DRAWING AMENDMENTS

REMARKS

ATTORNEY DOCKET
071308.0473

PATENT APPLICATION
10/696,705

FIG 3 Prior Art

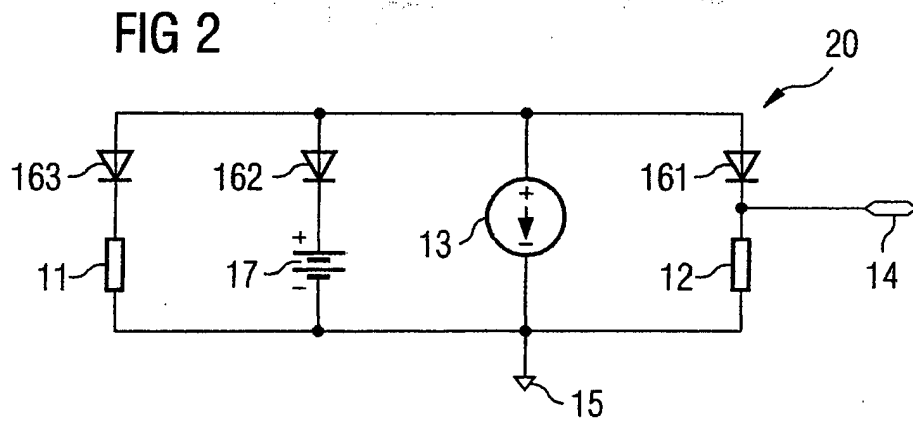
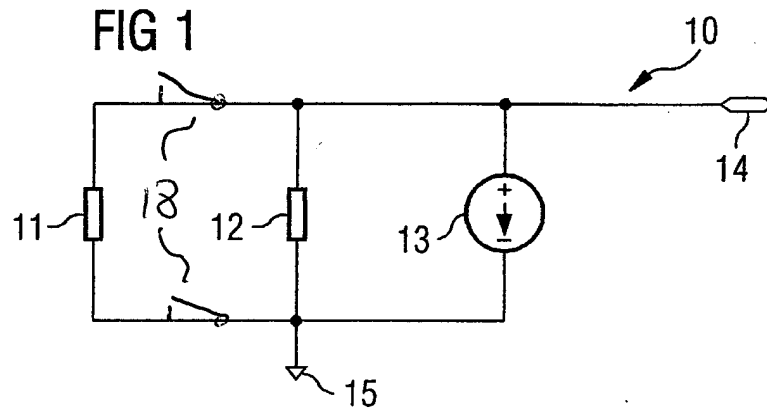
To this end, Fig. 3 showing the prior art now includes a first and second switch as switching means 18. The original specification states that switches are provided to couple the resistor 11 with ground and with the resistor network 321, 322, 323. The specification particularly states that the resistor 11 is “... *connected on one side, by switching means not shown, to ground 15. On the other side it is connected to a series circuit of voltage divider resistors 321, 322 and 323...*” (emphasis added) See specification page 13, line 17-19. Thus, Fig. 3 now shows these switches. No new matter has been added. With respect to Fig. 1, the specification states: “*Instead of the voltage divider circuit according to the prior art, a single reference or measuring resistor 12 is connected here in parallel to the calibration resistor to be recorded in each case.*” See page 14, lines 24-26. Thus, the switching means would be applied in a similar way as shown in Fig. 3. The amendments to Fig. 1, therefore, now also show the switches 18. With respect to Figs. 5A and 5B, Applicant amended these drawings as described in the original specification. The specification states: “*As can be easily seen, the entire calibration network can be connected to the calibration resistor of interest in the most simple way with the switching resources not shown a...*” See page 17, lines 1-3. The simplest way to connect a resistor to a circuit is a simple switch as now shown. Thus, no new matter has been added. Applicant believes that all necessary elements are now shown in the drawings as original disclosed.

art which understands how such evaluation circuits according to the prior art as exemplary shown in Fig. 3 work. The specification therefore concentrates on the new inventive part which is directed to the evaluation circuit proper as shown in Figs. 1, 2, 4, 5A, and 5b. Thus, Applicant believes that everything essential to the present invention is properly shown and disclosed. Thus, Applicant believes that all claims are allowable and respectfully requests allowance of the present application.

FIG 5A

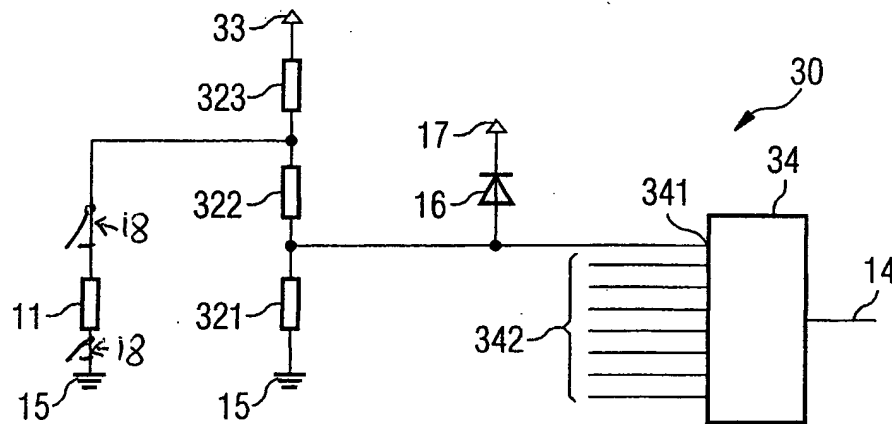
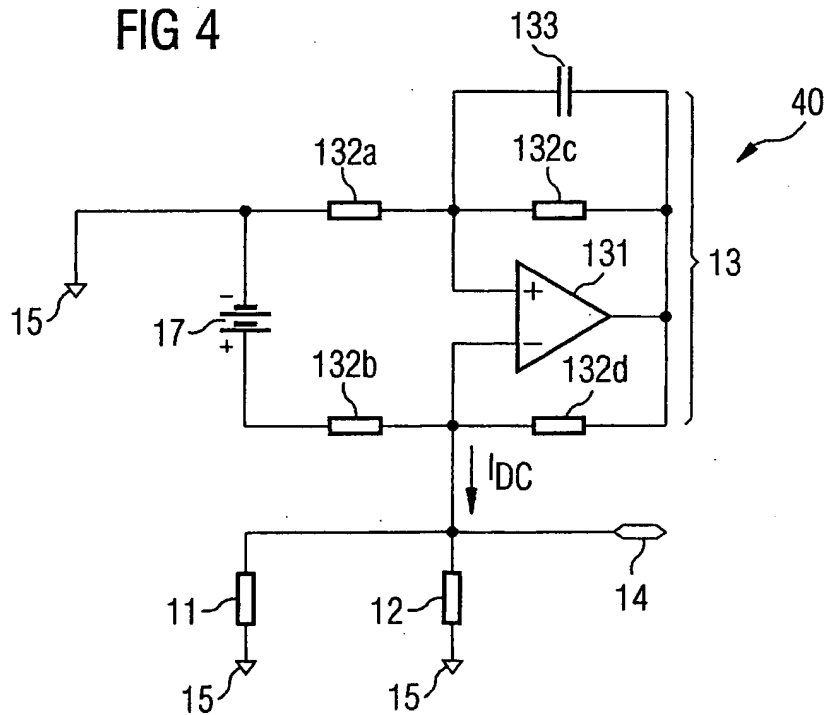
With respect to claim 4 the Examiner stated that the drawings fail to show the diodes. Applicant respectfully disagrees. Fig. 5A clearly shows diodes 163a...163h. For a better overview, Fig. 5A only shows a single resistor 11 coupled with diode 163a. Each other resistor is coupled with the remaining diodes 163b...163h in exactly the same way. Thus, there is no need to show these resistors and associated switches. The specification states: “*To improve clarity the calibration resistors to be connected to the decoupling diodes 163b-h are not shown in the diagram. The other components correspond to the relevant components with the same reference character in Figs. 1, 2 and 4.*” See page 17, lines 5-8. Applicant believes

by showing one resistor 11 coupled with the network, a person skilled in the art will not have any problems understanding how the remaining resistors have to be connected.
